April 17, 2009

Subject: Responses to February 19, 2009, EPA Letter Regarding the LTR Monitored Natural Attenuation (MNA) Summary Report

SHEET TITLE: **TRENDS IN RATIO BETWEEN
CIS 1,2 DCE AND TCE**

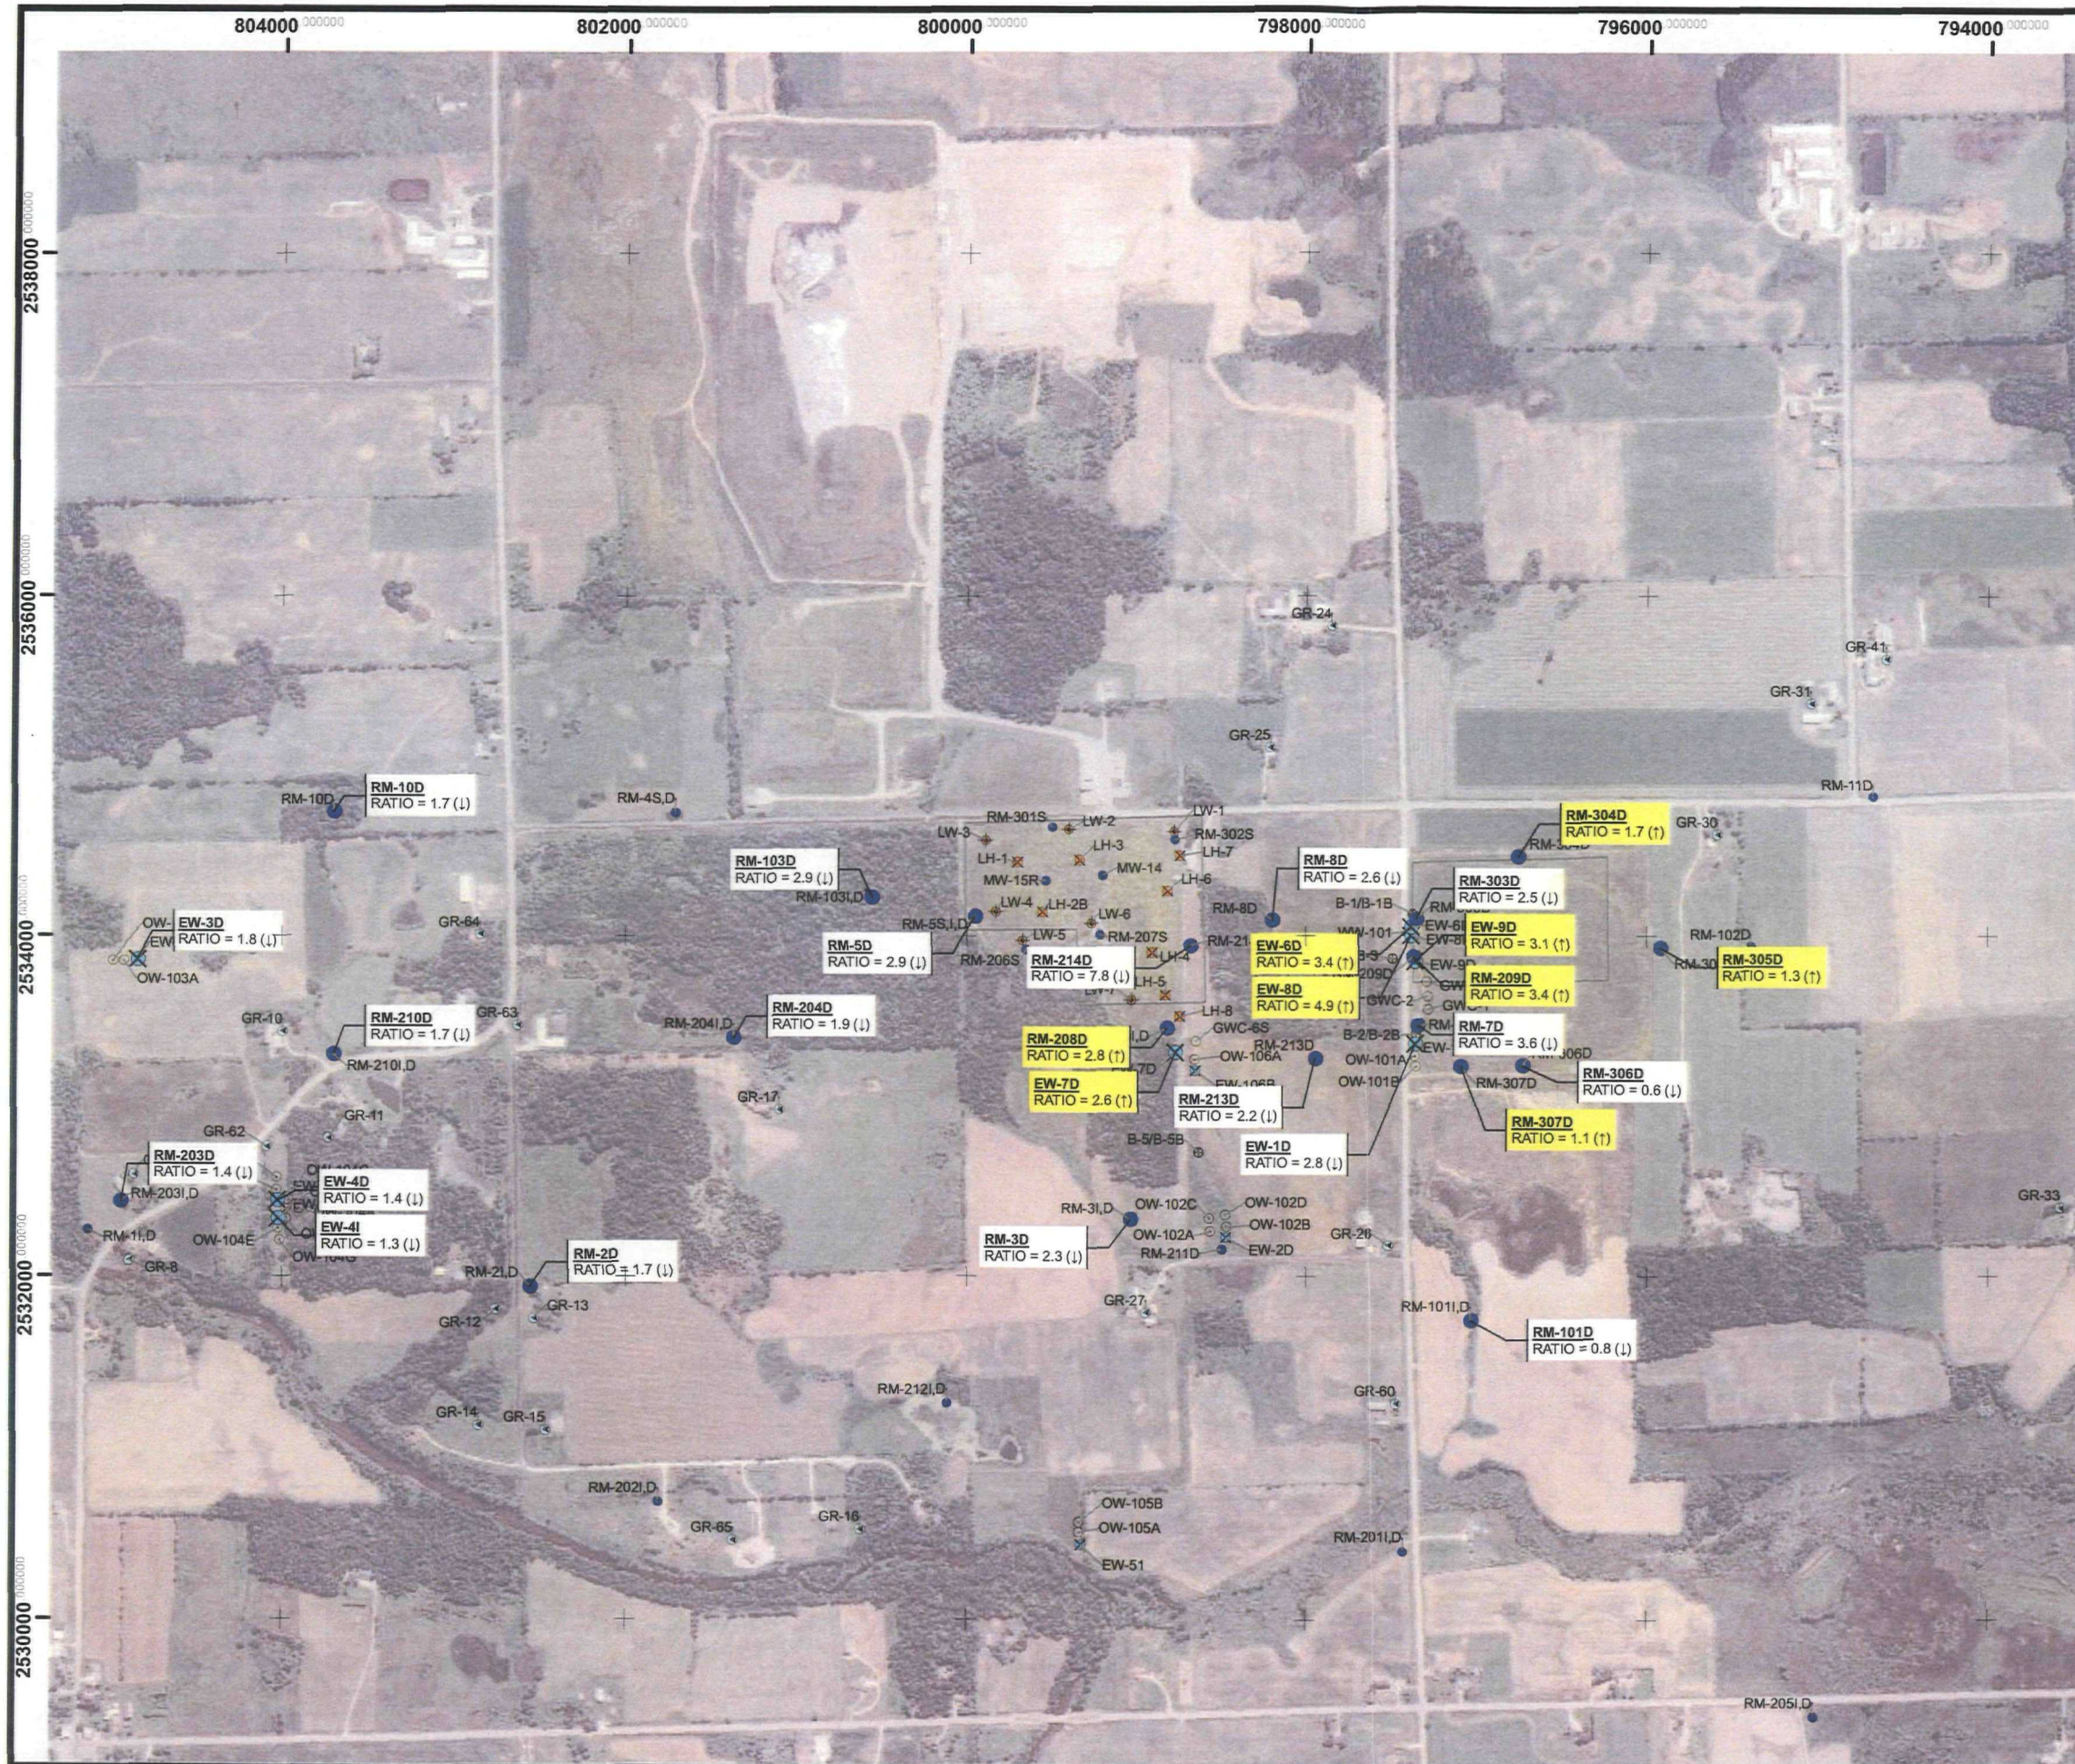
7. *The following tabulation indicates that the ratios of daughter to parent compounds are remarkably similar in far-field, near-field, and landfill groundwater.*

Inasmuch as it is unlikely that the degradation rates of the parent and daughter products would be equal, it is probable that the bulk of the degradation occurs very near the landfill, and that the lower downgradient concentrations are primarily the result of dilution. In general, there is a slight decrease with depth and distance from the source, which would be consistent with arrest of anaerobic degradation of parent compounds concurrent with some aerobic degradation of daughter products. Increases in the ratios for 1,1-DCA/1,1,1-TCA at RM007XXD (139-144 ft bgs), and for Cis/TCE at RM-208 suggests that there may be localized

These graphs illustrate the complexity of the system, but again, an apparent spatial relationship increased ratios in the source and near-field wells as compared to the far-field wells, as shown on the attached Figure A1, which illustrates the ratios of cis-1,2 DCE plotted at monitoring well locations. If, as suggested, reductive dechlorination was the only degradation process and it was occurring only in the source area, the ratios would be relatively uniform throughout the plume. However, the higher ratios of reductive dechlorination breakdown products in monitoring wells near the source indicate a depletion of breakdown products with respect to the parent compound with distance from the source. This is likely caused by a slowing of the reductive dechlorination and an increase in aerobic degradation, which would result in comparatively more rapid degradation of the breakdown products, as suggested.

In addition, the source and near-field wells more commonly show a steady increase in the ratio of cis-1,2-DCE to TCE with time, and the far-field wells generally show a decrease. This suggests that the wells closest to the source are still being supplied with organic carbon to fuel reductive dechlorination, while the more distal wells are becoming more depleted of organic carbon and generally more aerobic. This supports the concept that biotic activity is ongoing and, since the trends change spatially, they are not the result of dilution.

SHEET TITLE: **1,1,1-TCA CONCENTRATIONS
LGU AND BEDROCK UNIT-JULY 2008**

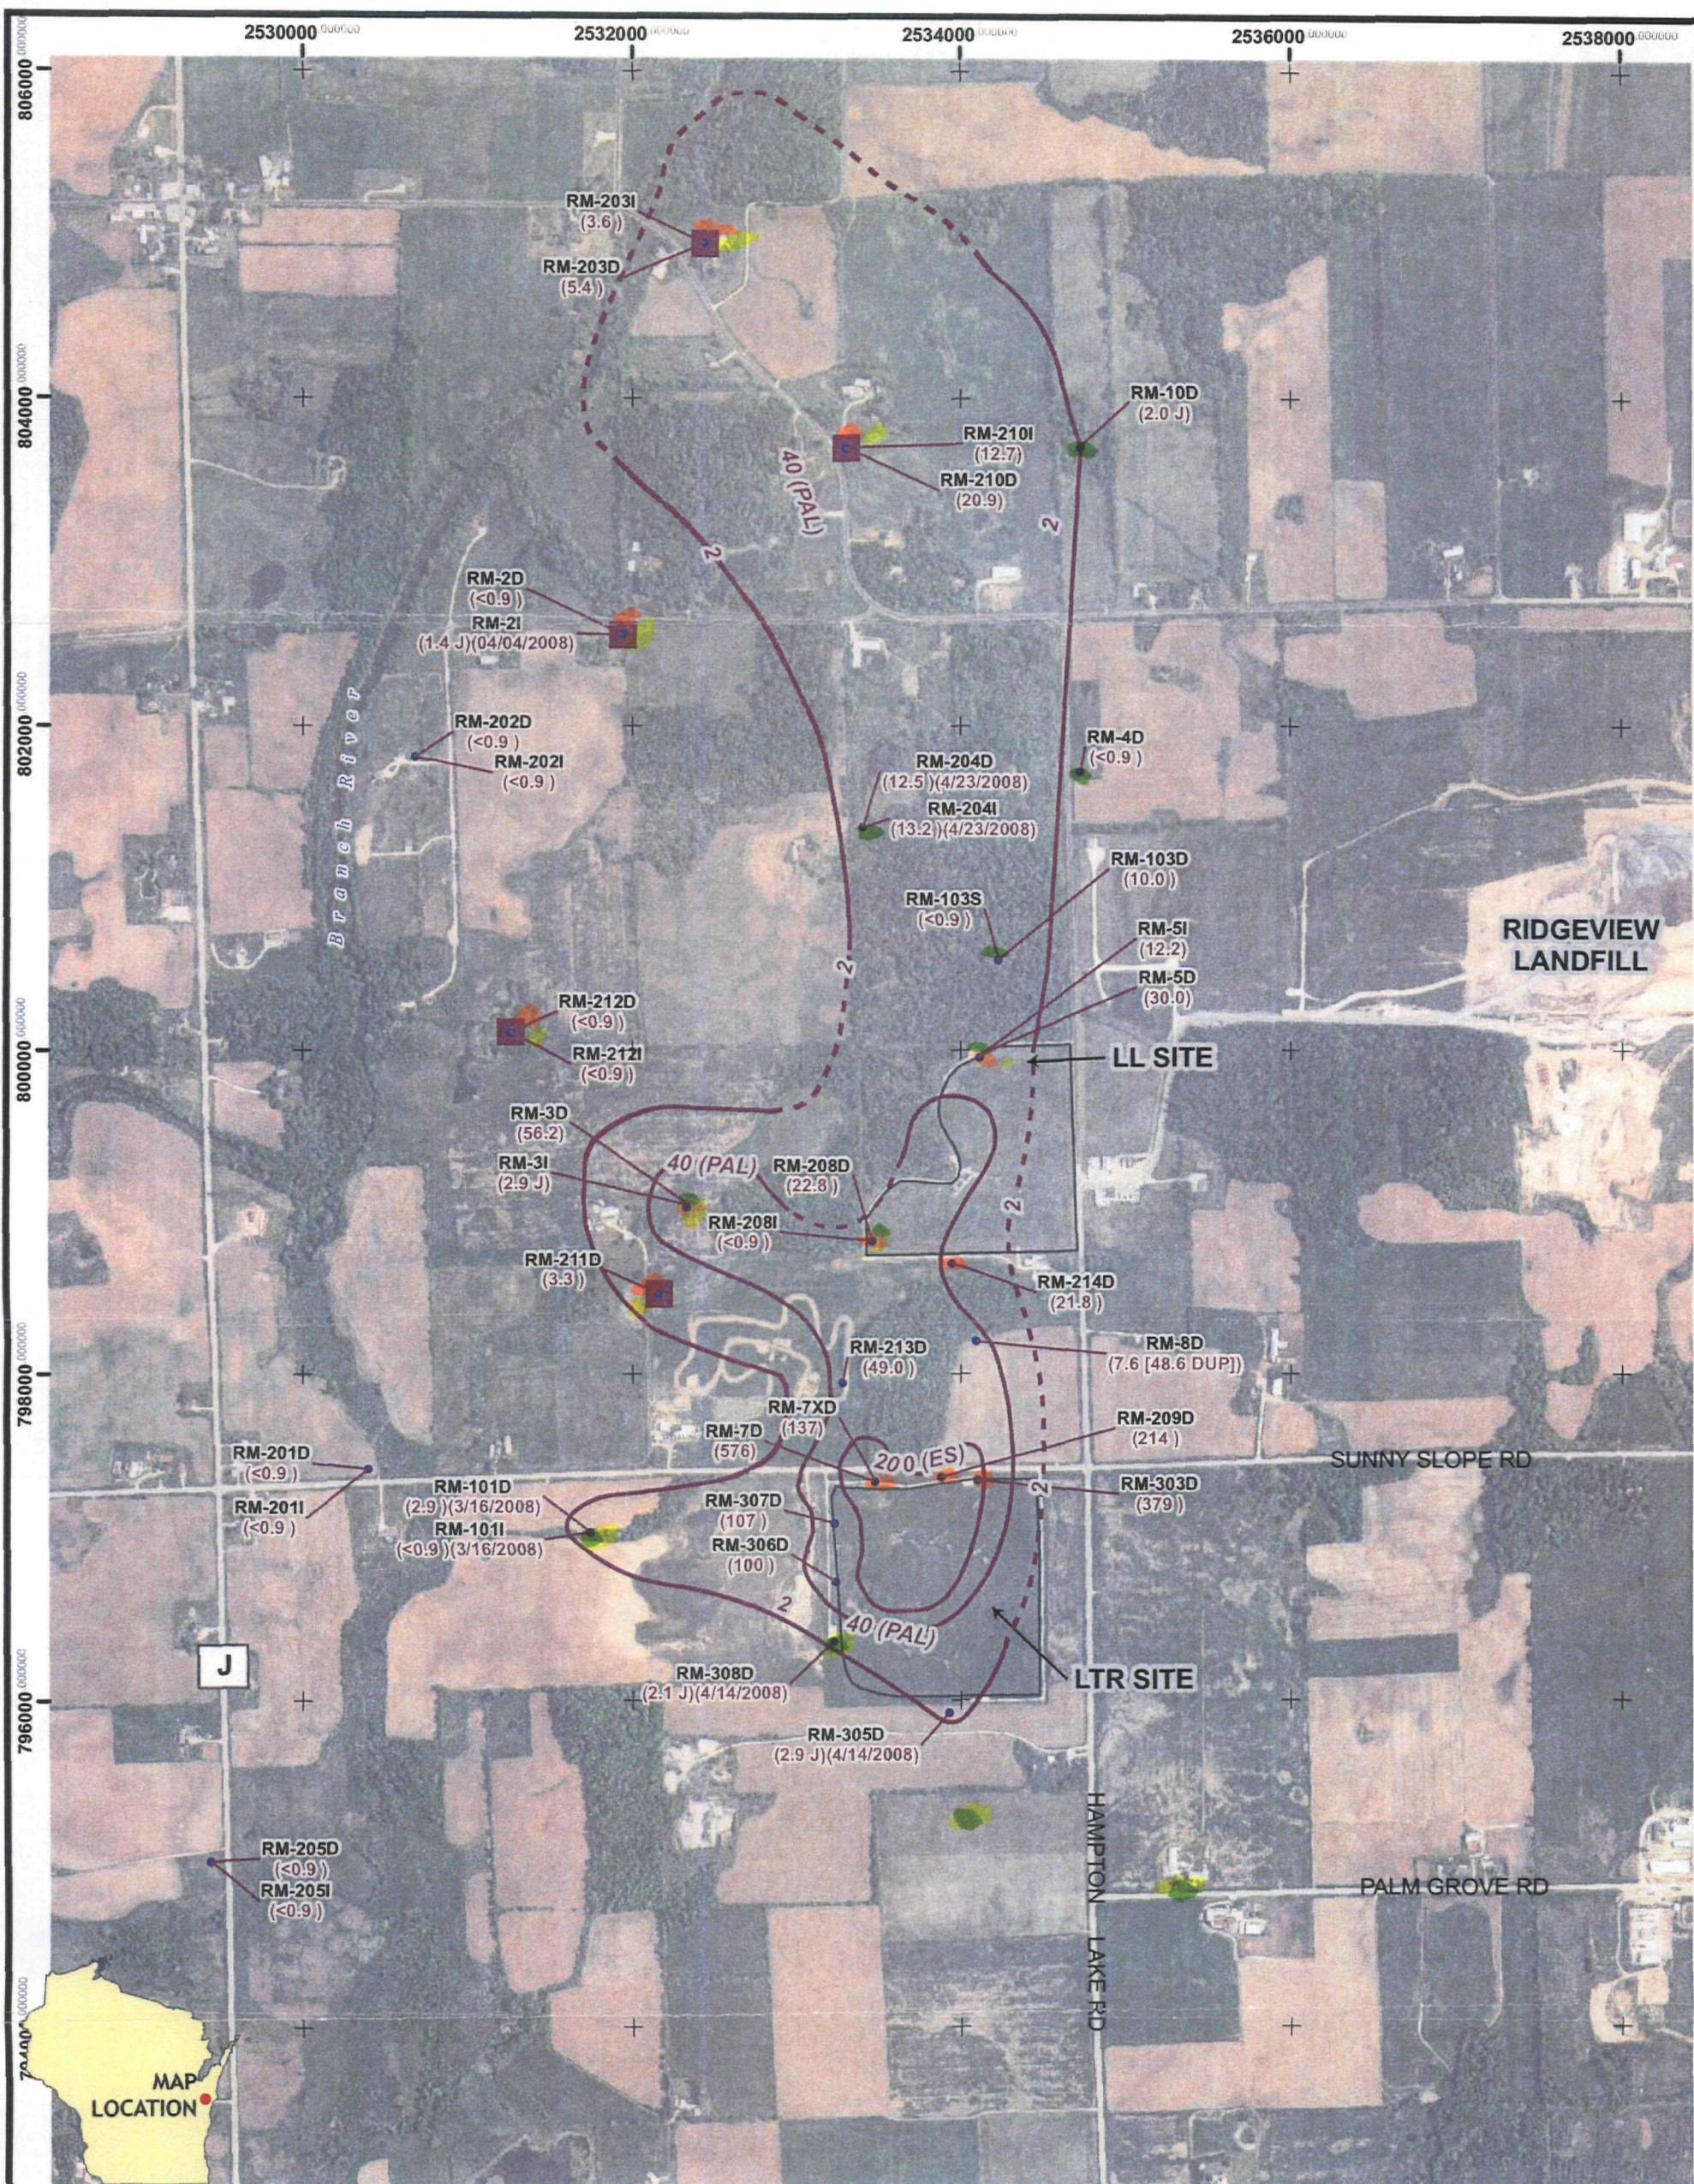
30. *Figure 2: Monitoring wells RM305D, RM308D, and RM211D have concentrations greater than 2 ug/l, but are shown outside the 2 ug/l isoconcentration contour.*

Response: Figure 2 has been revised (Attachment 10).
